RECALL ACTION

Reference number:	RA-63-1832	Issued: 05 April, 2024
Subject:	12V Battery PSS Fusebox	
Model:	DBX (all models)	
VIN Range:	Refer to the separately published list of affected Vehicle Identification Numbers (VINs)	
Applicable to:	All Markets (except China)	
Distribute to:	Aftersales Manager Executive Manager Service Manager Sales Manager	Warranty Staff Technician(s) Parts Staff

Figure 1

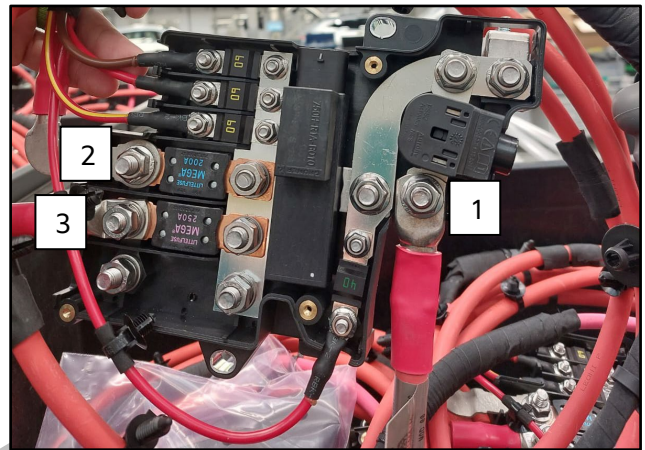
On the affected vehicles, it is possible that three M8 fixings in the 12V battery fusebox may work loose.

1. Disconnect the vehicle 12V battery (refer to Workshop Manual Procedure 63.01.AK).
2. Remove the cover for the fusebox (refer to Workshop Manual procedure 63.01.AR).
3. Remove the M8 fixings that follow (refer to Figure 1):

1. 'Dirty' feed - Starter motor, alternator, and front jumpstart point (pyrotechnic cut off switch)
2. Rear cabin fusebox (200A Fuse)
3. 'Clean' feed to engine fusebox (250A Fuse)

4. Do a check for any debris or signs of high temperature on the fusebox and cable eyelets.
5. Install the washer, split washer and flat M8 nut to each affected stud in the fusebox.
6. Torque the new fixings to 12 Nm.
7. Install the cover for the fusebox (refer to Workshop Manual Procedure 63.01.AR).
8. Install the liner for the spare wheel well (refer to Workshop Manual Procedure 30.03.PW).
9. Connect the vehicle 12V battery (refer to Workshop Manual Procedure 63.01.AK).
